Project:	West Coast TTPP (District Plan Review)	Document No.:	Ca 002 R01		
То:	WCRC	Date:	23 January 2025		
Attention:	Ruth Evans	Cross Reference:			
Delivery:	email	Project No.:	20230665		
From:	Steve Peakall	No. Pages:	4	Attachments:	Yes
Subject:	Potential Kiwirail Overlay

## The TTPP has a rule for noise insulation near the Rail network

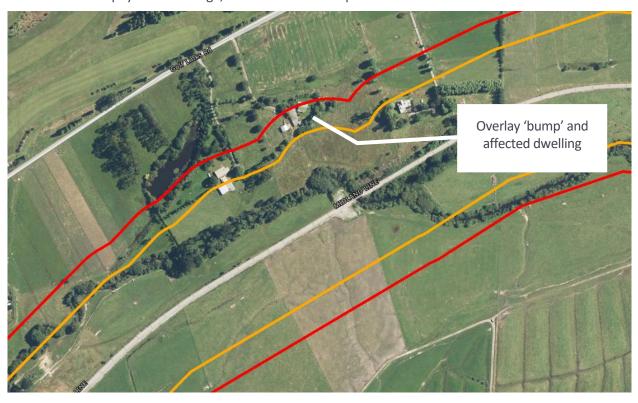
Because of the nature of the Designation, which includes additional geographic areas for ancillary operations (sidings, access roads etc) there are several instances where the resultant overlays extend over houses that

would never realistically be as close as 100m (from a noise perspective) or 60m (from a vibration perspective) to the cause of the noise/vibration emission (i.e. trains using the tracks).

The implication therefore is that the potential rule framework may require these dwellings to mitigate the effects of railway noise/vibration that would never eventuate in practice. This may be considered too onerous by the Panel.

An example of this anomaly is shown in the image below, where a house falls within the rail noise overlay (red line) because of an access way being part of the Designation for a small part of the rail alignment, which pushes the overlay out in a 'bump' at this point. Either side, the Designation offset follows more closely the actual track, and therefore the offset overlay distance is consequently less.

There is an existing dwelling where this 'bump' occurs, meaning it would theoretically have to mitigate rail noise should an alteration to the house be sought in accordance with Noise Rule R3. By using a setback distance from the physical track edge, this would not be required.
